## PLANNING AND DEVELOPMENT SERVICES STAFF REPORT

For Planning Commission Meeting of May 17, 2016

**SUBJECT: 615 South Main Planned Project Site Plan  
(615-637 South Main Street)  
Project No. SP15-054**

Systems Planning  
Project Management  
Project No. SP15-054

**Gas Station Existing Condition**

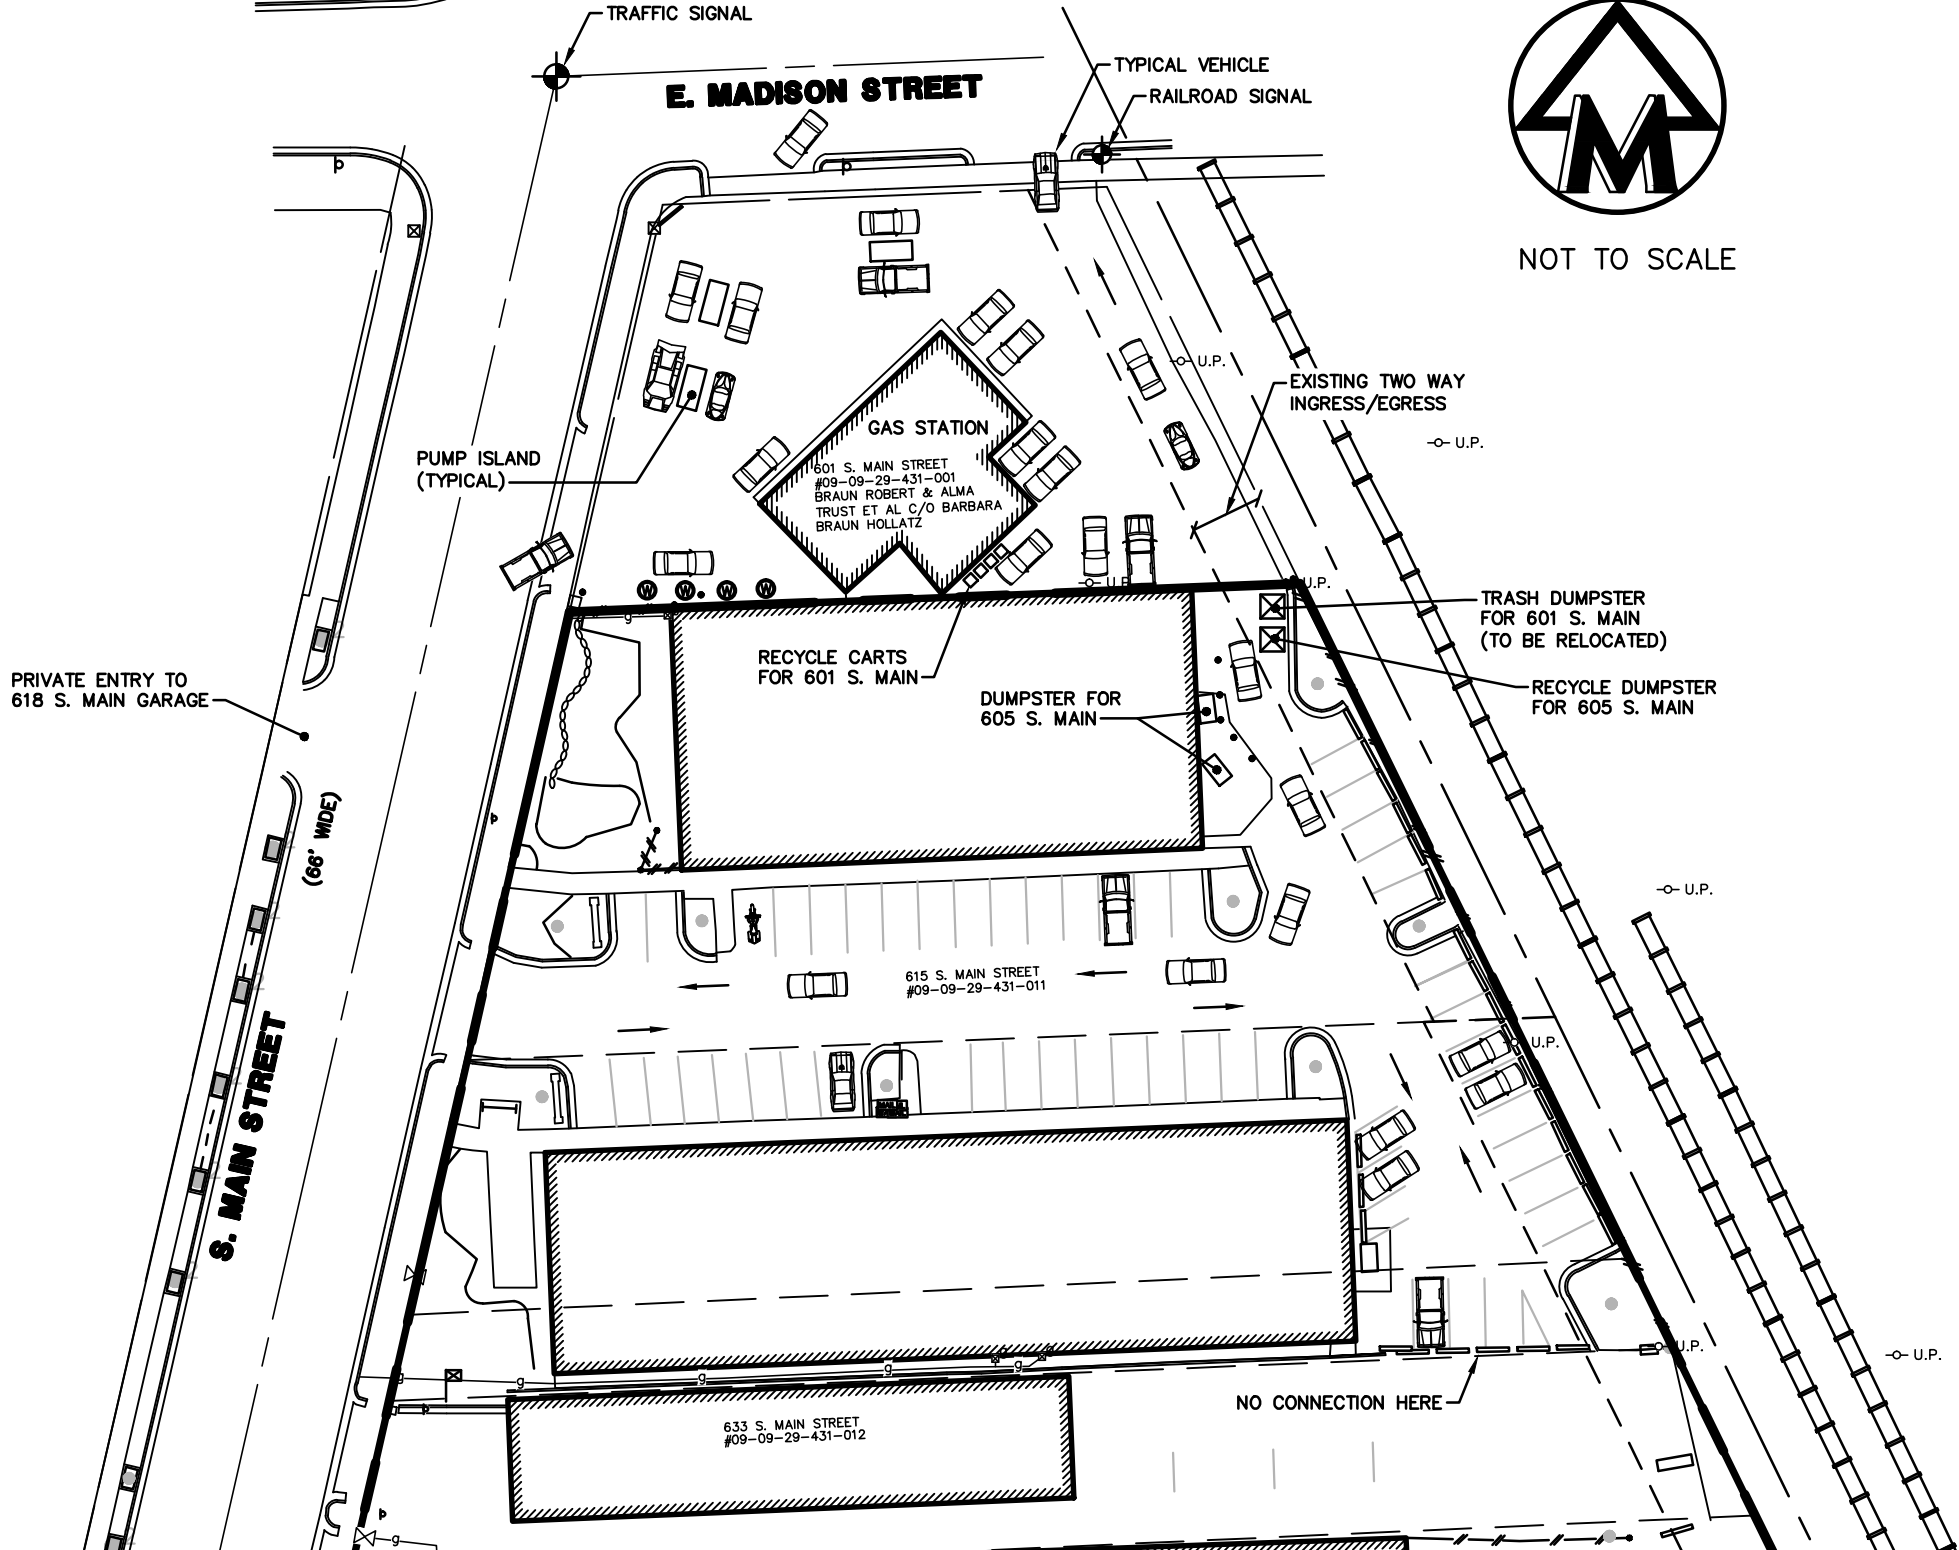
Pedestrian Travel Through Gas Station Property – The petitioners are now proposing a 6 foot wide colored and stamped concrete surface to delineate a pedestrian path through the gas station property.

April 7, 2016  
**THE RESIDENCES AT 615 S. MAIN**  
 Ann Arbor, MI  
 Preliminary Courtyard Sketch  
 Midwestern Consulting  
 Project No. 15200

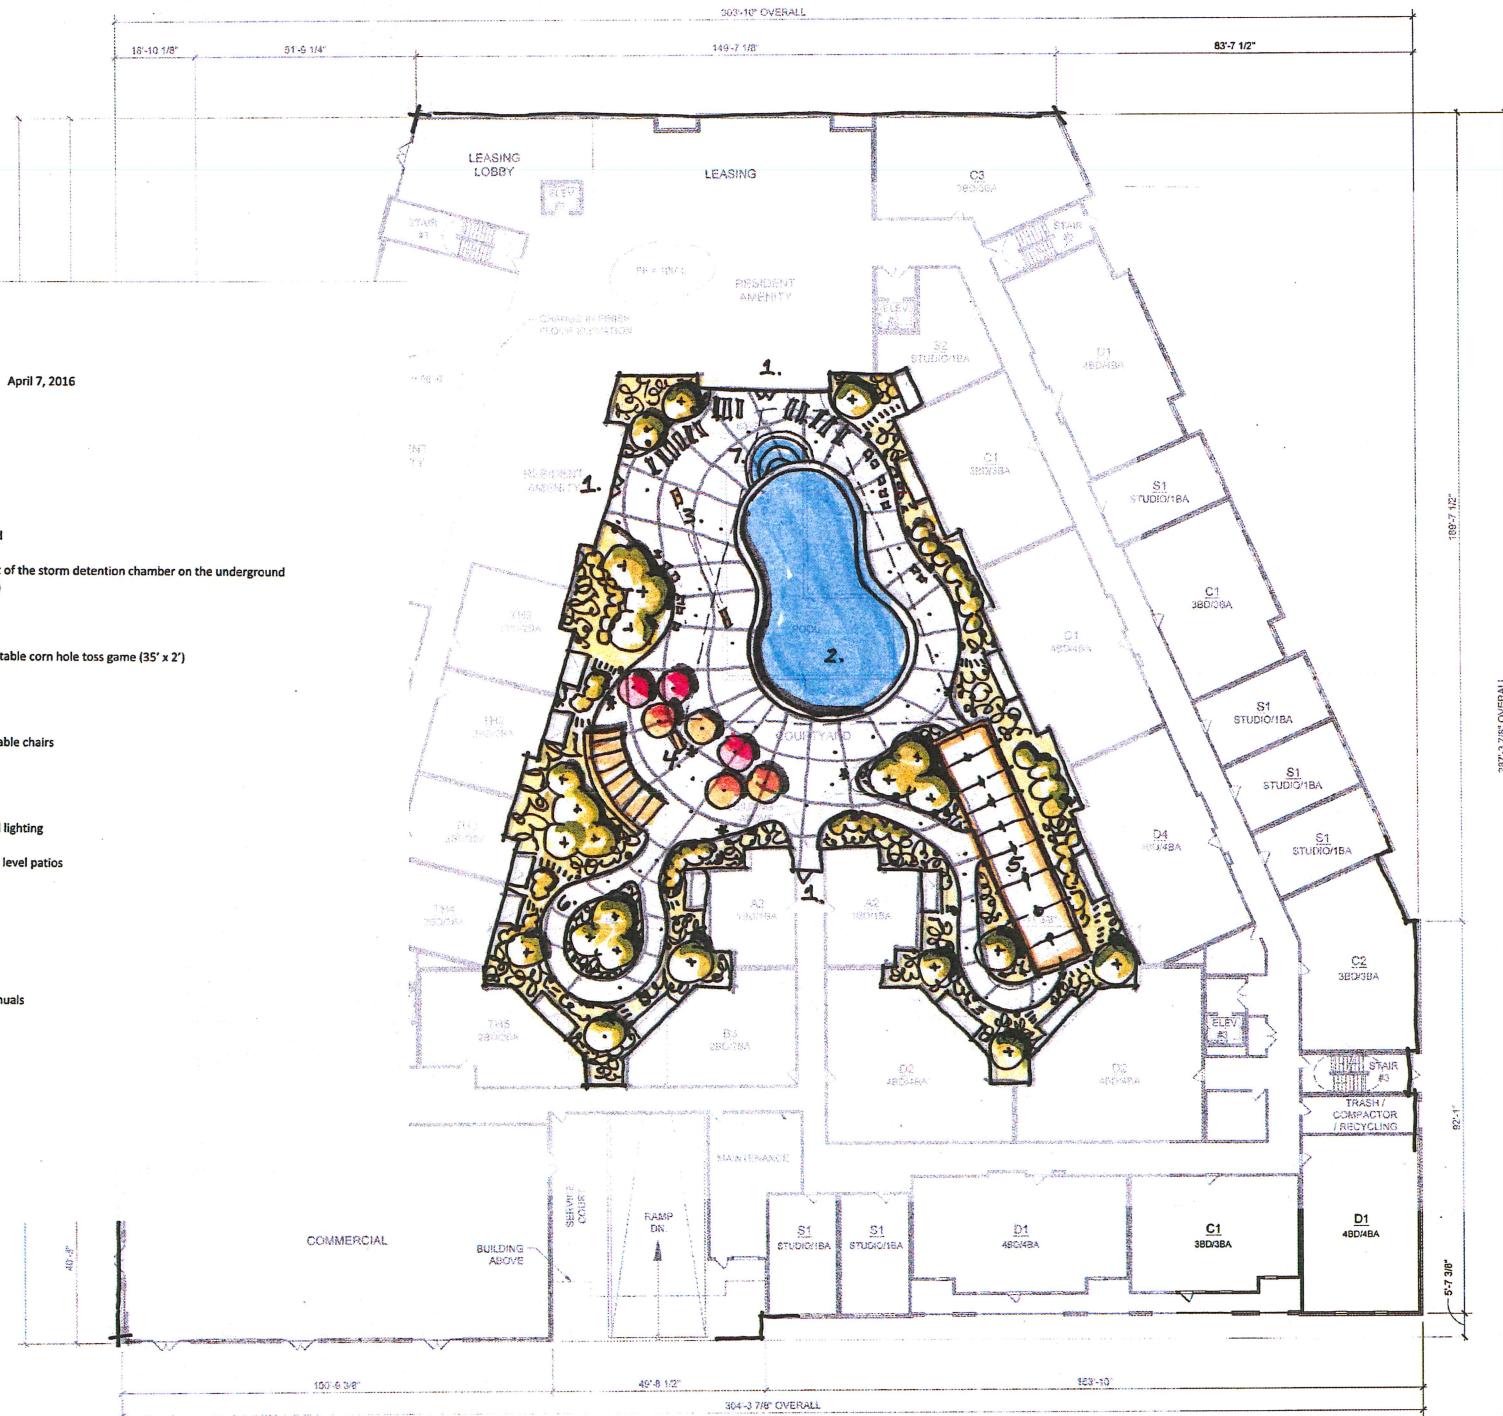
Design of Interior Courtyard – The petitioner has proposed a sketch of how the interior courtyard will be designed (see image in attached memo).

**Questions were raised about design of the interior courtyard and what it could contain.**

- KEY**
1. General resident entries to courtyard
  2. Lounge pool
    - Pool is fitted within the footprint of the storm detention chamber on the underground parking level below (dashed line)
    - Seat wall edge
  3. Pool deck
    - Sunning
    - Hard surface active use area/portable corn hole toss game (35' x 2')
    - Potential special paving
    - Moveable furniture
  4. Outdoor kitchen/dining area
    - Pergola
    - Tables with umbrellas and moveable chairs
    - Pedestrian level lighting
    - Outdoor fireplace or fire pit
  5. Bocce ball court
    - 12' x 60' minimum
    - Overhead trellis with ornamental lighting
  6. Garden and pathway areas
    - Stepping stone links to courtyard level patios
    - Bollard lighting
  7. Hot tub/spa
- Large shrub/small tree
  - Medium/small shrubs
  - Ground cover/perennials/annuals
  - Pedestrian lightpole
  - Bollard light
  - Trellis lights

**615 S. MAIN ST.**  
PLANNED PROJECT SITE PLAN  
DIMENSIONAL SITE PLAN

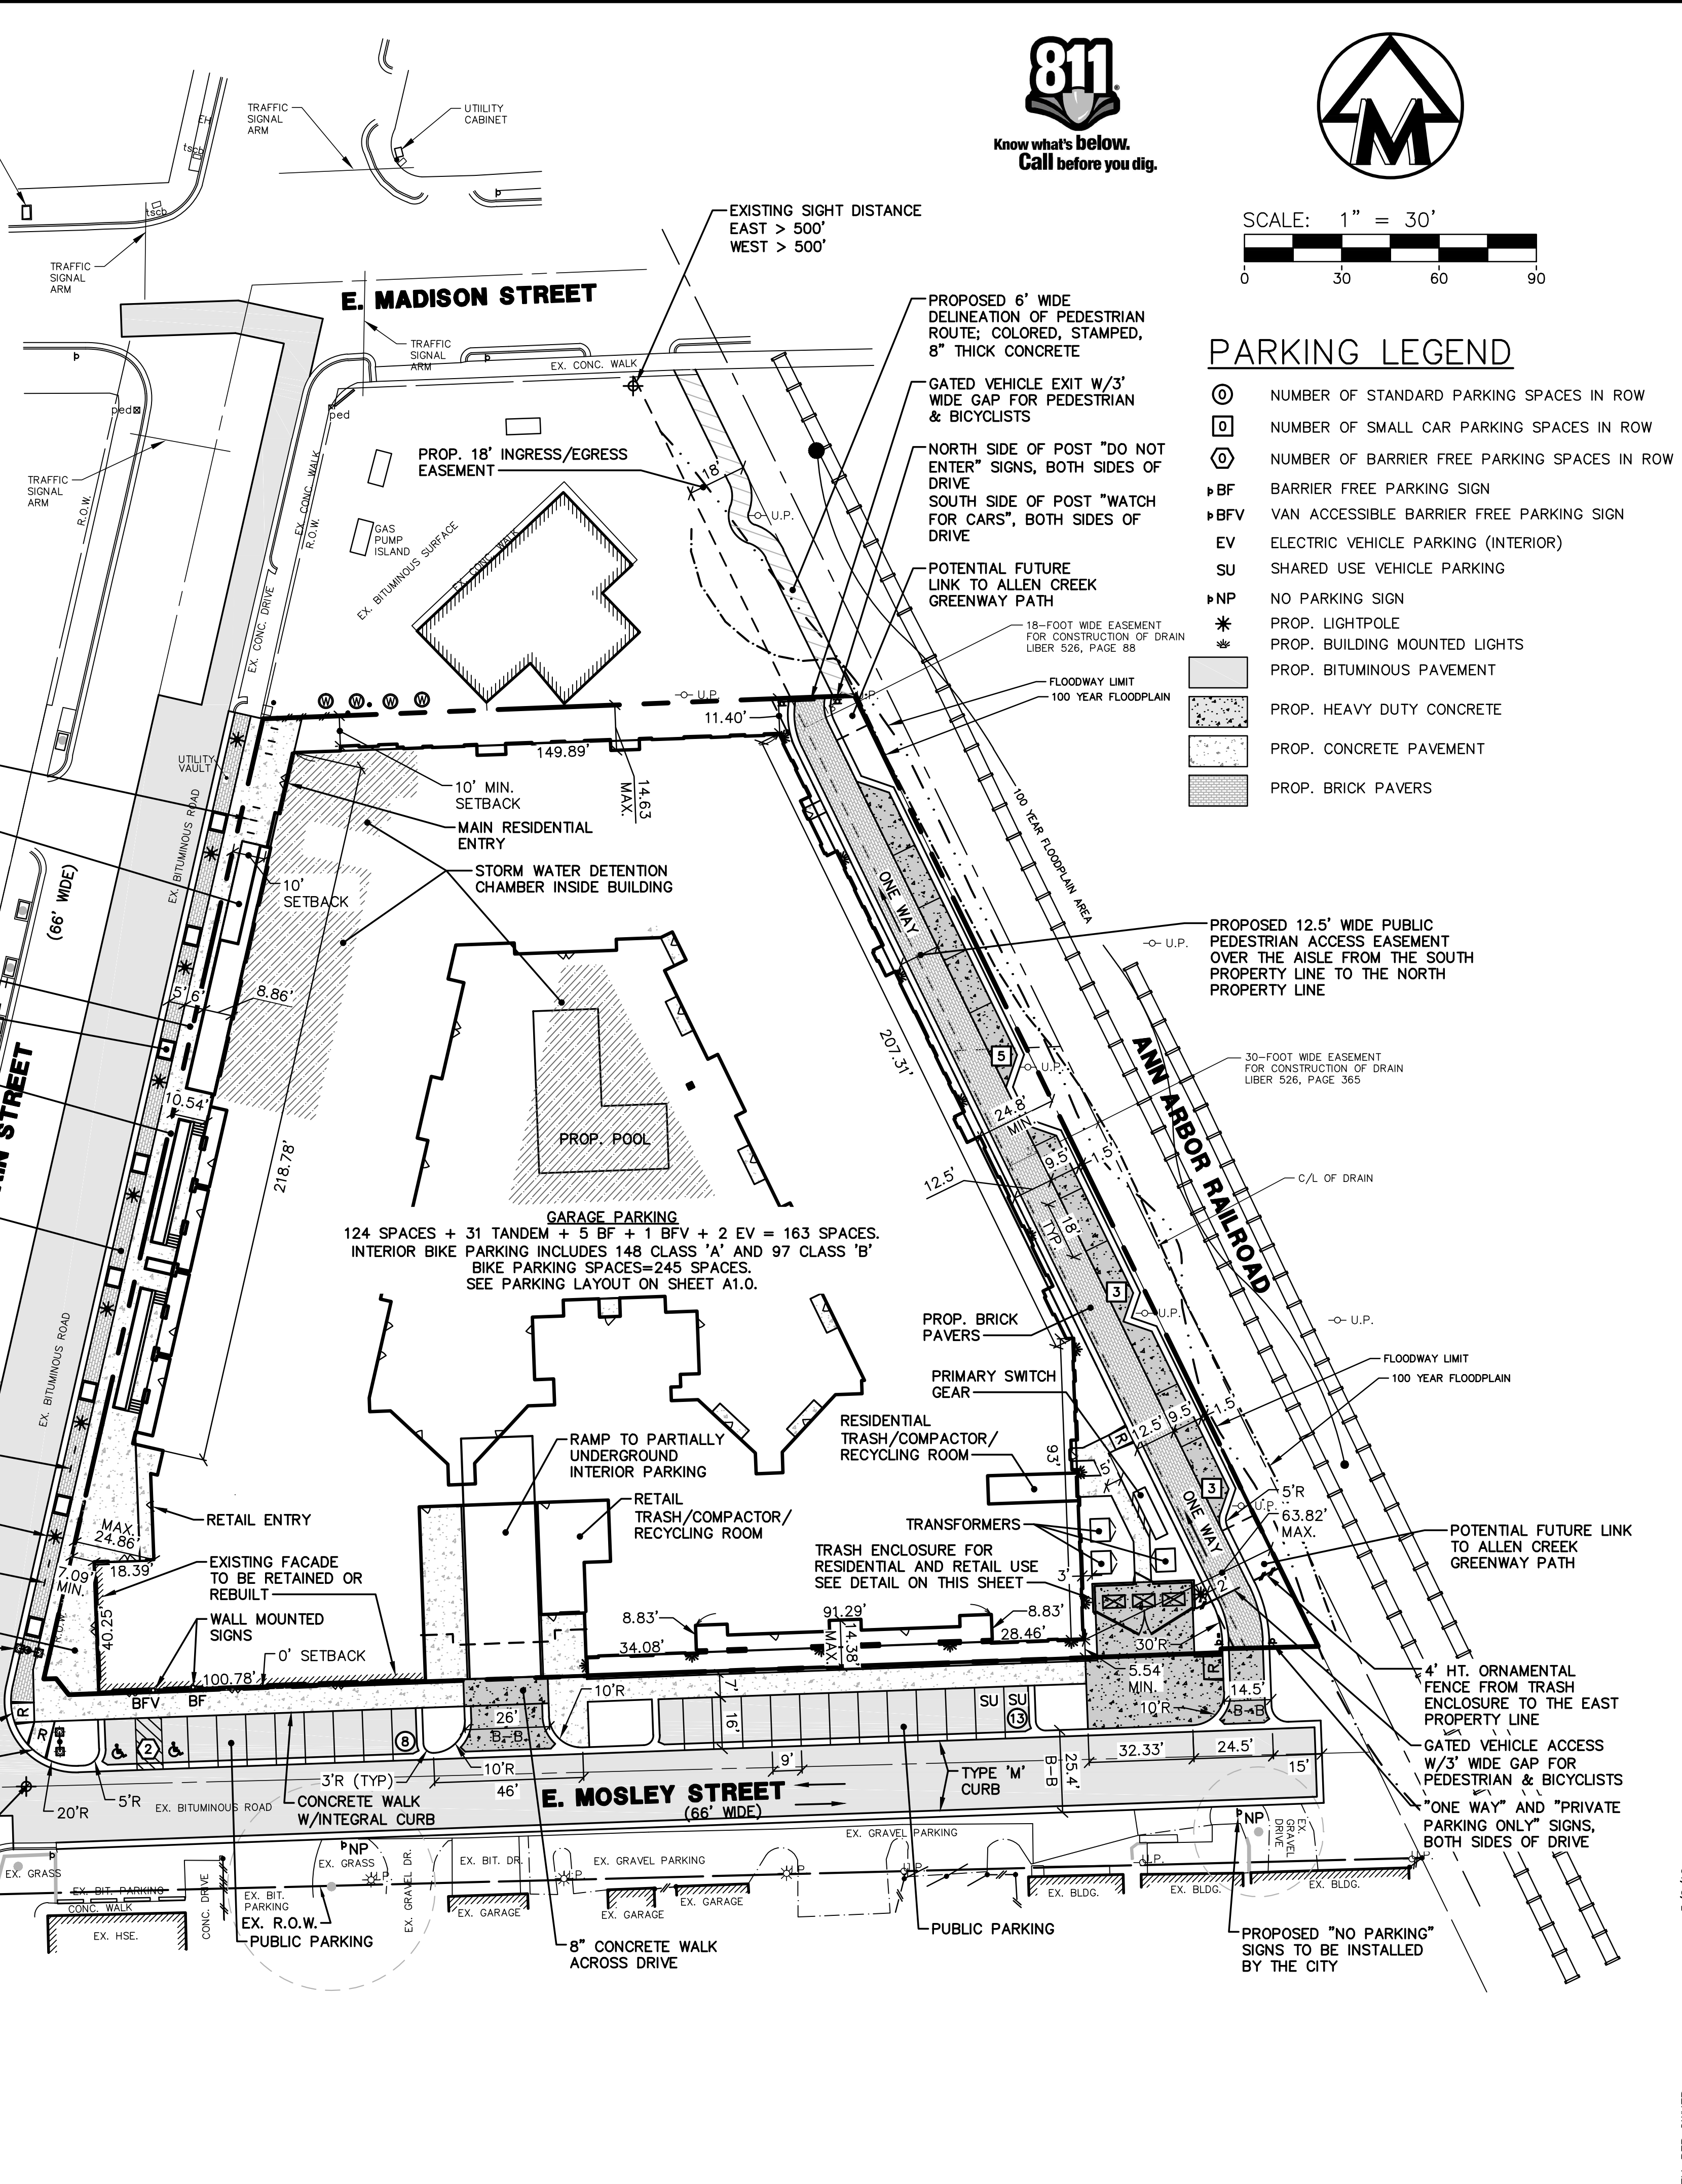
Traffic – The petitioner met with City Public Services staff to discuss various traffic issues. The primary staff concern was with the number of vehicles driving along the east property line to Madison and then going east over the railroad tracks. The only vehicular trips proposed to leave the site from the east access drive will be those vehicles which park along the east drive. Controlled access will be provided with gates at the north and south ends of the access drive. Eleven parking spaces are now shown along the east drive (a reduction from 13 spaces). Since egress trips from the east access drive will be very few and since some vehicles will turn west on Madison, staff has accepted this proposed egress.

Parking Spaces – Two parking spaces were removed from the east access drive to facilitate distance requirements for electrical equipment and to provide two new trees. 12 spaces have been removed from the basement which will leave a total of 174 parking spaces, a reduction from 188 spaces that were originally proposed.

Landscaping east of the building includes landscape beds against the building and interior landscape islands with trees in between some of the parking spots. Two of the parallel parking spaces within the parking lot have been deleted and four small/medium size trees have been added. (Large trees cannot be installed there because the adjacent overhead utilities are to remain.)

**Another modification to the eastern private parking lot was made**
